Subject: Collin County Healthcare Facility, Parking Garage, and Medical Examiners  
Revised PCO No. 081; RFI #260 Added Louver Detail Metal Flashing

Project: 224057- Collin County Public Health Buildings  
2300 Bloomdale Rd  
McKinney, TX 75071

Issue No. 081- RFI #260 Added Louver Detail Metal Flashing Amount

## RFI #260: All - Submittal Comments Follow Up RFI EPS Drip Edge

**BRICK @ LOUVER HEAD, TYP.1** 3" = 1'-0" **13**

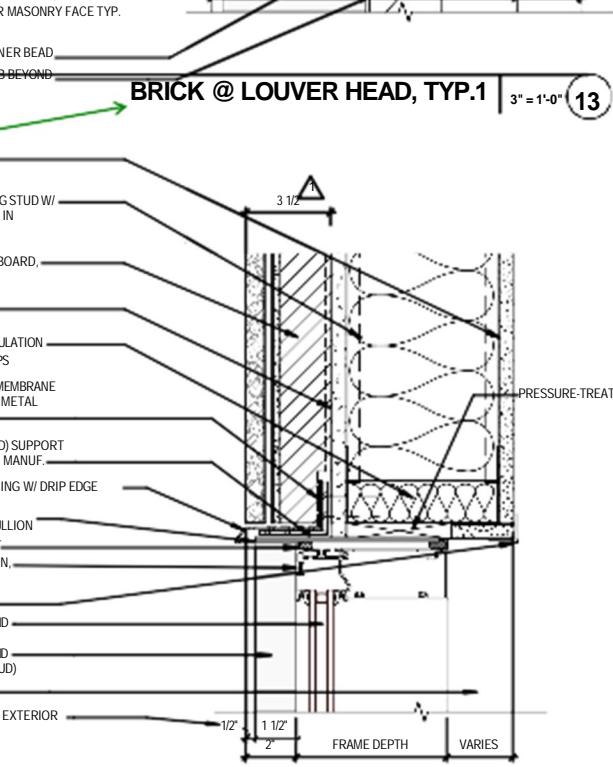
- **Added metal flashing scope around louver openings according to details added in new construction documents distributed in RFI 260 response.**
  - **Includes additional glazing scope of work to provide and install additional metal flashing around the louver openings scheduled for the Medical Examiner's Building.**
  - **Metal flashing around Parking Garage louvers not needed per PGAL.**
- *This PCO will be an add in the amount of \$3,782.*

Add 10" painted .090 aluminum flashing at 2 locations at ME building at louvres above doors

**BRICK @ STOREFRONT HEAD, TYP.1** 3" = 1'-0" **4**

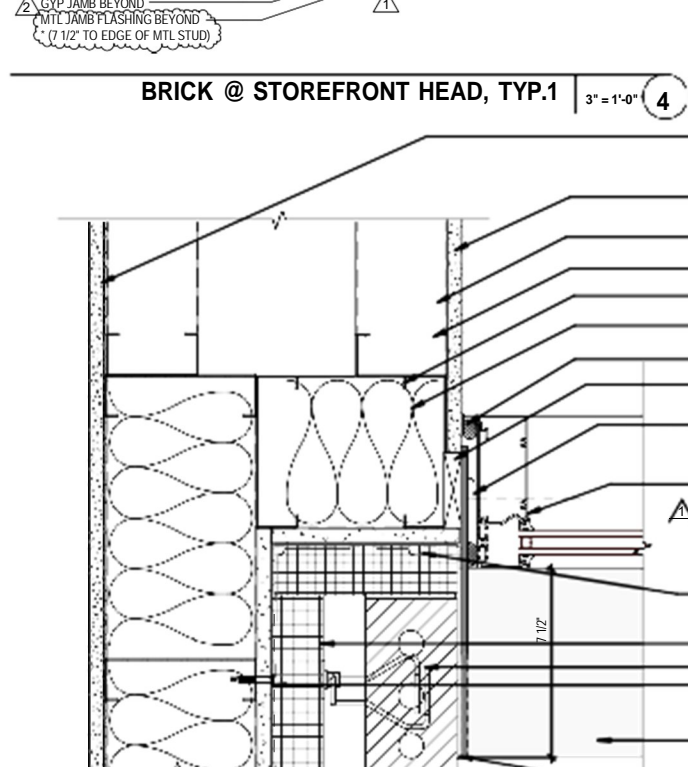
Per the architect's comments on the mockup approval submittal review, a drip edge is to be provided on all EPS shapes that match the detail provided in the submittal comment. Please provide updated construction drawing details to capture this change.

**PLEASE SEE UPDATED DETAILS 4 & 7 ON SHEET HC-A0.45 + DETAIL 8 ON SHEET ME-A0.45, FOR THE CONTINUOUS DRIP EDGE ON THE EIFS SHAPES ABOVE OPENINGS.**

**PLEASE ALSO SEE THE UPDATED DIMENSION DEPTH FOR THOSE EIFS SHAPES TO BE 8 1/2" DEEP.**

**DETAIL 4 - CONTINUOUS DRIP**  
**HC-A 0.45**

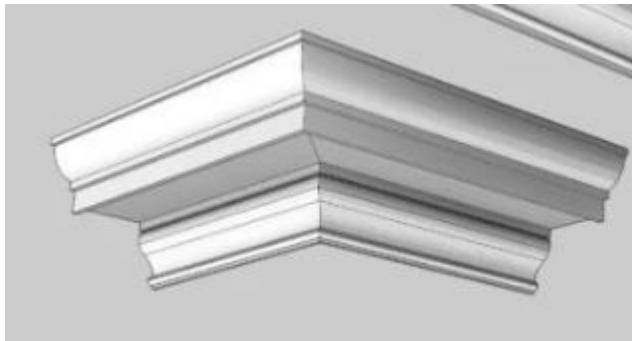
1. Check for drip edge and make sure there is a slope on all EIFS shapes. – All Buildings.

Architect: Please specify the details, included in the contract drawings, that show this drip edge for each building and each EIFs foam shape/location i.e. parapet, above storefront/curtain wall, watertable, etc. Otherwise, to be constructed per construction drawing details.

DRIP EDGE ONLY AT EIFS SHAPES THAT MATCH DETAIL 4
